**REGIONAL INTEGRATED LOOP SYSTEM
PHASE 3B INTERCONNECT PROJECT**

PEACE RIVER MANASOTA REGIONAL WATER SUPPLY AUTHORITY

ADDENDUM NO. 1

Date Issued: May 29, 2019

ADDENDUM 1 - UNDERWATER PIPE TEST STATION DETAIL

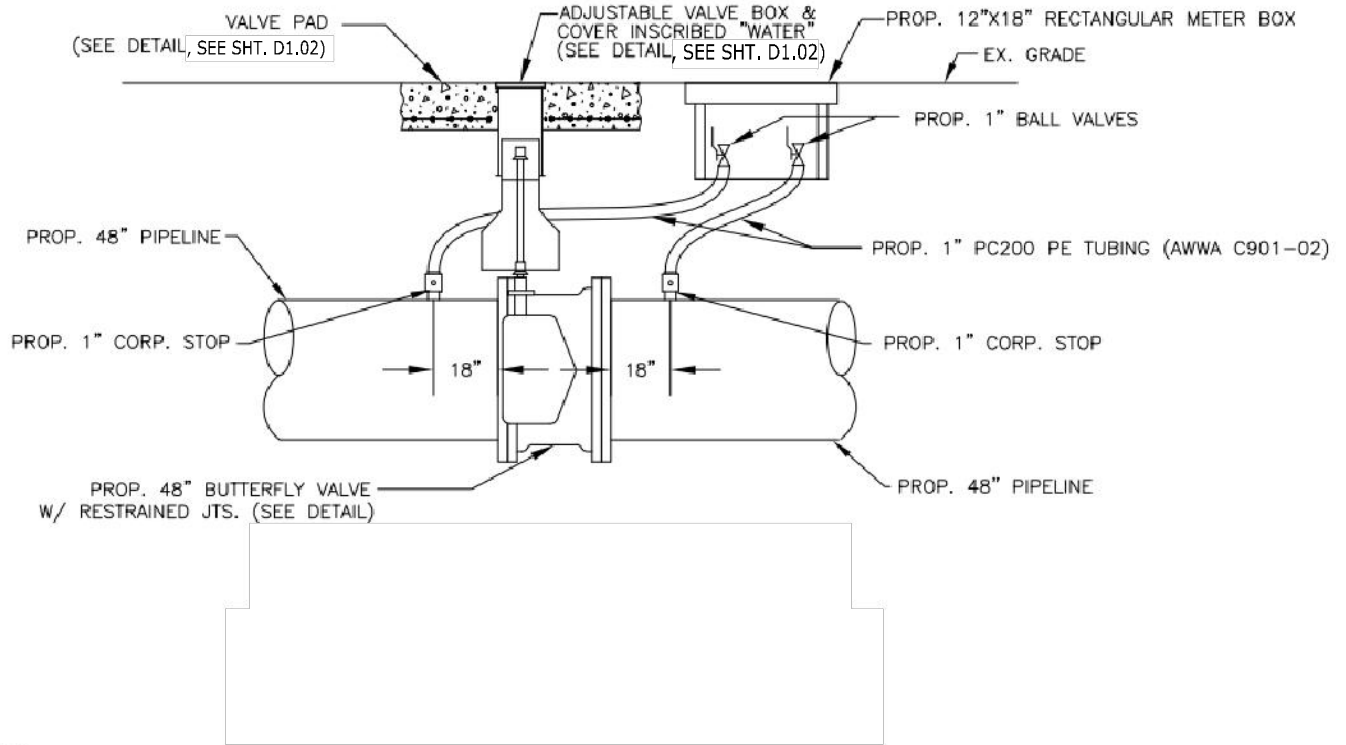
1. **REPLACE** the note on Sheet No. C1.08 that reads: 48” MJ BFV w/ Inspection Manhole See Detail Sht. D1.04 with the following: “48” MJ BFV And Underwater Pipe Test Station See Detail Sht. D1.04”
2. **ADD** the following note to on Sheet C1.25:
“See Sht. C3.03 for continuation of 30” WM”
3. **REPLACE** the note on Sheet No. C2.01 that reads: STA 729+17 7’ RT 48” MJ BFV w/ Inspection Manhole See Detail Sht. D1.04 with the following: “STA 729+17 7’ RT 48” MJ BFV And Underwater Pipe Test Station See Detail Sht. D1.04”

1. CONTRACTOR SHALL FABRICATE AND SUPPLY THREE (3) PRESSURE GAUGE ASSEMBLIES TO PR/MRSA FOR THEIR USE.
2. PRESSURE GAUGE ASSEMBLIES SHALL INCLUDE A GAUGE CAPABLE OF ACCURATELY READING PRESSURES FROM 0 TO 250 PSI IN INCRIMENTS OF NO LESS THAN 2 PSI, AND ALL NECESSARY CONNECTION PIECES TO CORRECTLY CONNECT TO THE SUPPLIED BALL VALVES.
